Report Type: DA Access Report
Reference Number: 18146
Client: Design Corp
Site Address: 30 Mitchell Street, St Marys NSW

ACCESS REPORT

This Access Compliance Report is to accompany a Development Application for the development proposed at 30 Mitchell Street, St Marys NSW

Post-adaptation layout

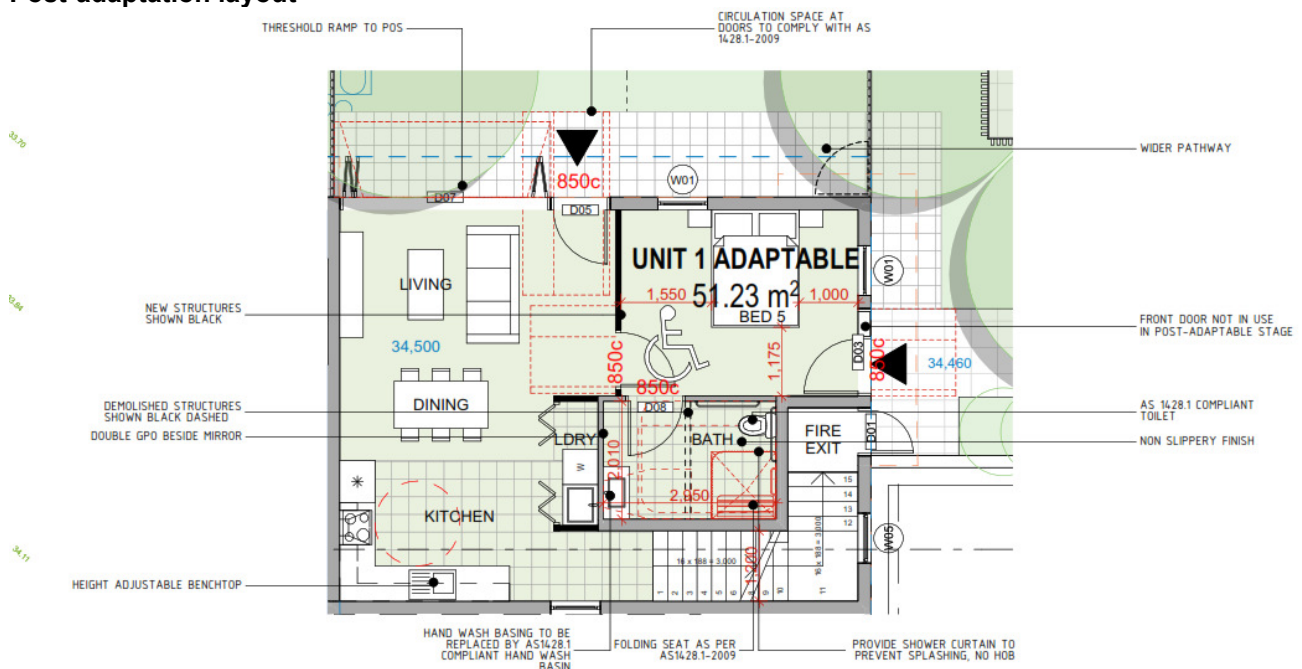
Note: Access is not required to the first-floor level of the unit as post adaption will provide all requirements to the ground floor including a bedroom, bathroom, laundry, kitchen and living area at post adaptation stage. A visitable toilet has been provided at pre-adaptation.

Main bedroom

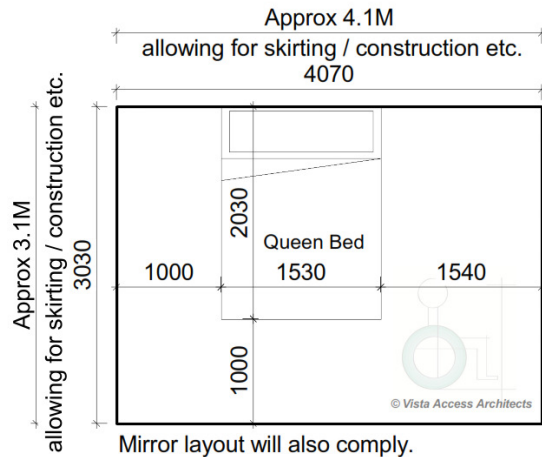
At least one bedroom of area sufficient to accommodate a queen size bed and wardrobe and circulation space requirements of AS1428.2

Complies
Details to be verified at the CC stage

Main Adaptable bathroom

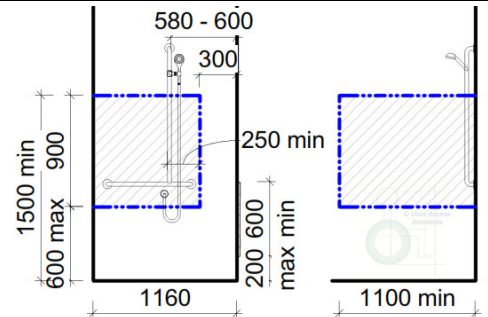
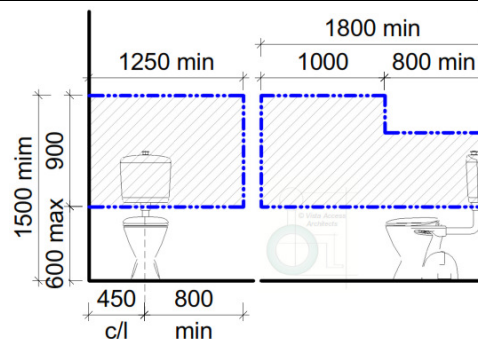
- Provision for bathroom area with Circulation spaces of Shower and WC (including fixtures) to comply with AS1428.1.
- Note that wall reinforcements and waterproofing details to comply with AS4299

Complies
A bathroom with minimum space of 2Mx 2.95M or 2.3Mx2.7M or 2.4Mx2.45M is achievable. Wall reinforcement details to be verified at the CC stage.
